Interactive comment on “Can we trust remote sensing ET products over Africa?” by Imeshi Weerasinghe et al.

Received and published: 23 September 2019

Overview We want to thank the reviewers for their dedication in reviewing the manuscript. We also are thankful for their thoughtful and constructive suggestions and comments. We have addressed all the comments raised by the reviewers and the manuscript has improved from the proposed changes.

Fig. 1. Calculated statistics, bias, bias_{aw}, RMSE, RMSE_{aw} and r for the comparison of the long-term annual average ET_{WB} versus ET_{RS}

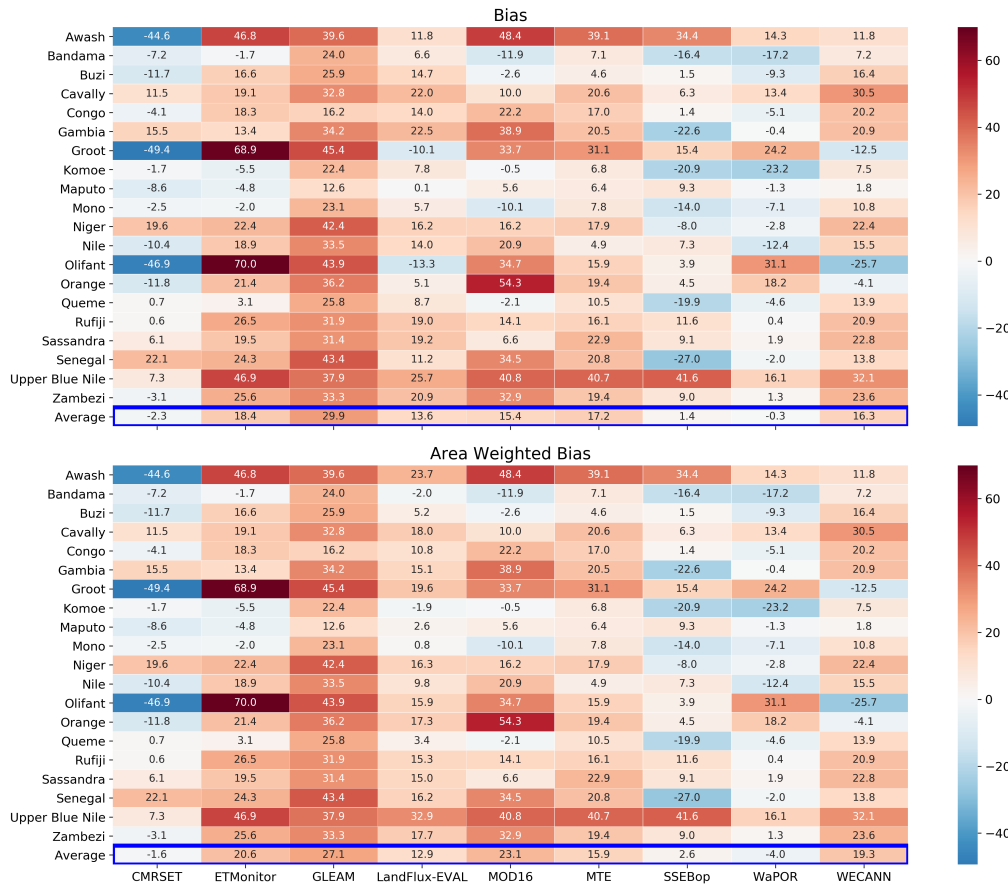
Reviewer 2, Specific Comment 5 – Methodology and results My advice would be to not use percentages for all the figure results. This only confuses the interpretation. Use -1 to 1 scale for correlation and differences.

Authors Response We did not use percentages for the overall statistics in Table 5. However, we still used percentages when looking at bias and basin area weighted bias as subjectively we found these results easier to interpret and was given this advice from different advisers of the manuscript. (Table 5) Authors Changes in Manuscript

Fig. 3. Spatial assessment across Africa of each ET product based on selected land cover elements, forest, irrigated areas and water bodies

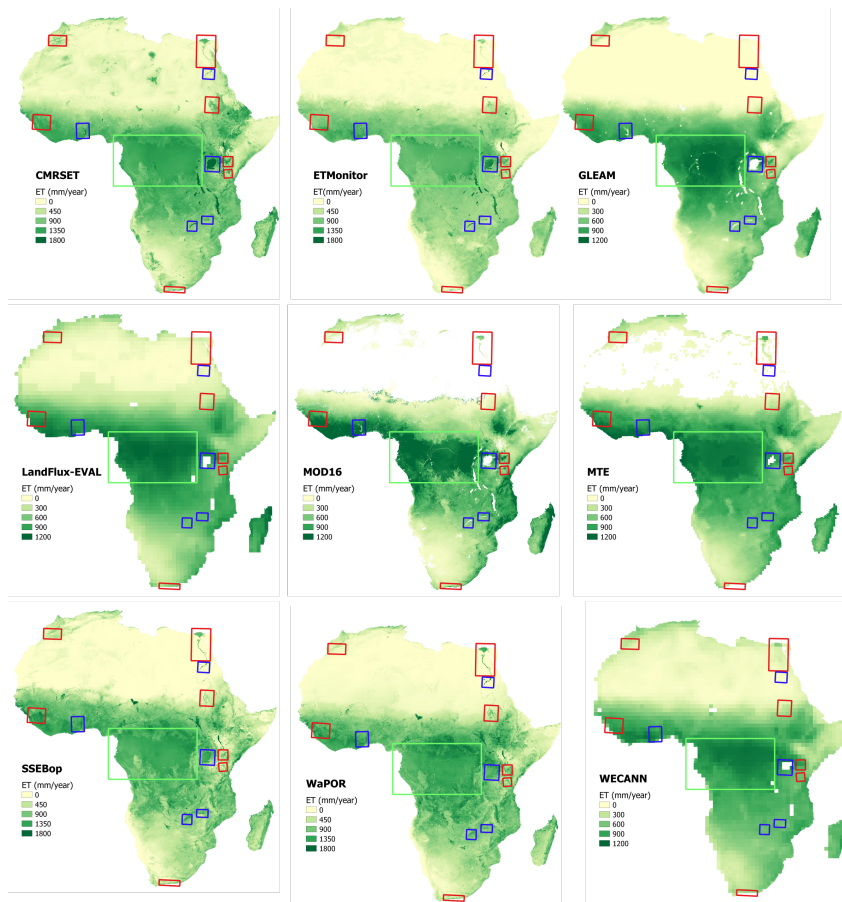
Reviewer 2, Specific Comment 6 – Methodology and results The raking of products based on visual inspection is rather speculative for me. For ex on Fig 9 it was impossible to follow the text conclusions: I did not see where irrigation C7 HESSD Interactive comment Printer-friendly version Discussion paper area is, to which reference product other products are compared, why MPM and some other products have no data and why GLEAM is concluded to perform worst? The same for Fig 10..

Reviewer 2, Specific Comment 7 – Methodology and results The analyses of comparing products over one irrigation area, and one lake, where some products have no data, and others do not even resolve the region does not make much sense to me, nor it is complete enough to make a serious conclusion on which product is better or worst.

Authors Response We re-did this section to include forest as an additional land cover type for inspection as well as using highlighted areas across the entire African continent rather than zooming into selected areas shown in figure 5. We agree that this is a rather subjective method, however, we also believe it is relatively visible to see the difference between the products especially when using different scales to be able to visually interpret the results. We believe these maps are an added advantage for reader interested in spatial characteristics of ET. However, due to its potential subjectivity in ranking, we do two final rankings, with and without visual inspection to minimise this subjectivity. (P13,L4), (Figure 10) Authors Changes in Manuscript “Figure 10 shows ET across Africa for all ET products with the specific land cover elements (forest, irrigated areas and water bodies) highlighted. Two different scales are used in order to be able to visually compare the products according to spatial variability rather than magnitude of ET. For products where large biases were found, a scale of 0-1200 mm/year was used and for the remaining products a scale of 0-1800 mm/year was used. Visually, all products capture the forested area. Irrigated areas are also captured well by most products. GLEAM and LandFlux-EVAL do not capture the majority of selected irrigated areas. CMRSET, ETMonitor, SSEBop and WaPOR capture most of the selected irrigated areas while the remaining products capture a few. GLEAM, LandFlux-EVAL, MOD16, MTE and WECANN only estimate land ET and thus do not have ET across water bodies. The remaining products capture the water bodies well, with CMRSET and ETMonitor showing larger differences in their estimations of ET across water bod-

Fig. 6. Comparison of the EWEMBI, CHIRPS and MSWEP precipitation products on their prediction of mean P across the basins

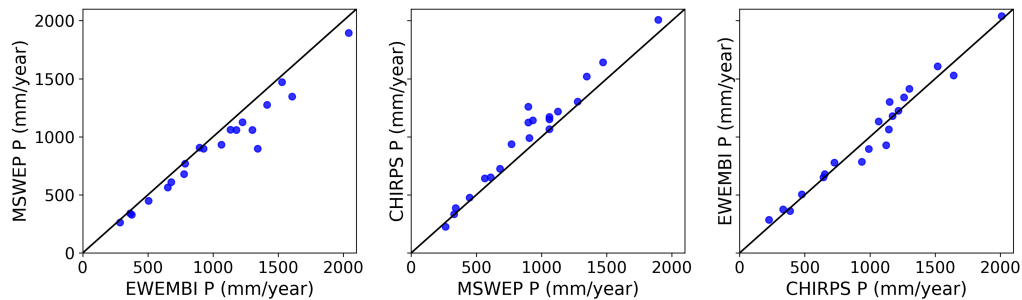
Reviewer 2, Specific Comment 3 – Scientific Relevance The study does not mention anything at all about the quality of the reference precipitation data sets, nor about the quality of the final WB- based ET product. The study should also provide or mention some quantitative assessment to the magnitude of the differences which arise only due to application of different rainfall products. This will (i) - substantiate introduction of three different rainfall products in the paper and (ii) – justify better the obtained differences in ET between the products. Authors Response We have now used the average of the three precipitation products due to only slight differences found in the calculated mean precipitation between the three products also considering that we use the average of the three products for ranking purposes. The comparison between the three precipitation products have been included in the paper. We have also tried to evaluate the reasons behind the differences between the ET products within the conclusion. This was already mentioned somewhat in the discussion (P5,L23), (P9,L25), (Figure 5), (P20,L15). Authors Changes in Manuscript

“Precipitation and potential evapotranspiration were taken as the average of three products. Here we compare the results of the different P and PET products for the basins being analysed. We see that the three precipitation products show little differences in their estimations of long-term average P across the basins. No large outliers can be seen (Figure 5).”
